Subject: 21043 Mack Avenue: Site Plan for Dunkin Donuts' / Baskin Robbins
Parcel ID: 003-06-0095-000
Site Plan: Review #2
Zoning: C, Commercial Business District

Site Plan Review

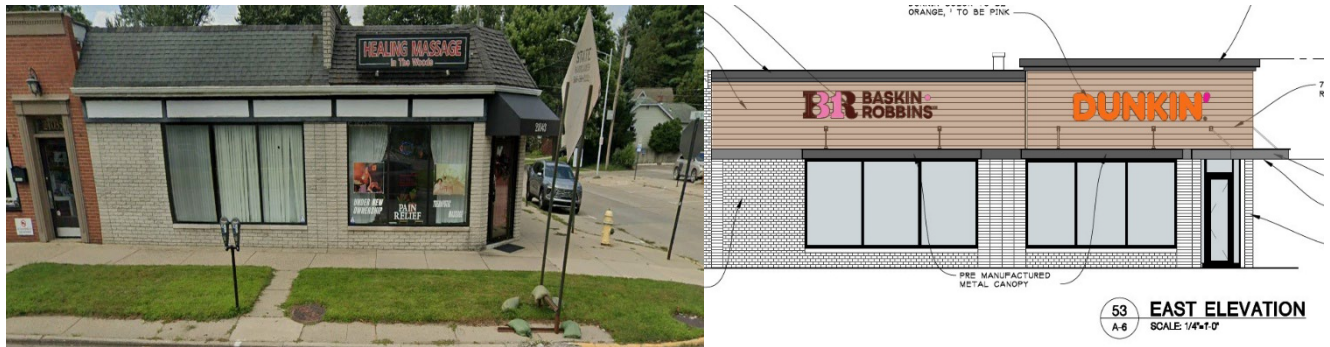
Findings: Can Comply. The proposed exterior building alterations include replacement of the existing hip roof feature with a more modern parapet, preservation of the existing light brick, and incorporation of materials such as cement lap siding with wood textures in light tan, and metal banding (see images on the following page).

The proposed façade renovations are more consistent with the architectural styles encouraged in the Zoning Ordinance. The revised building design, façade materials, and colors now provide closer alignment with the traditional commercial character along Mack Avenue.

Final building design and materials are subject to Planning Commission approval. It is recommended that the Applicant bring physical samples of the proposed building materials to the meeting, as available.

Please note, the material labels must be corrected on a revised site plan – there are currently labels for both fiber cement panels and fiber cement lap siding on the elevations.
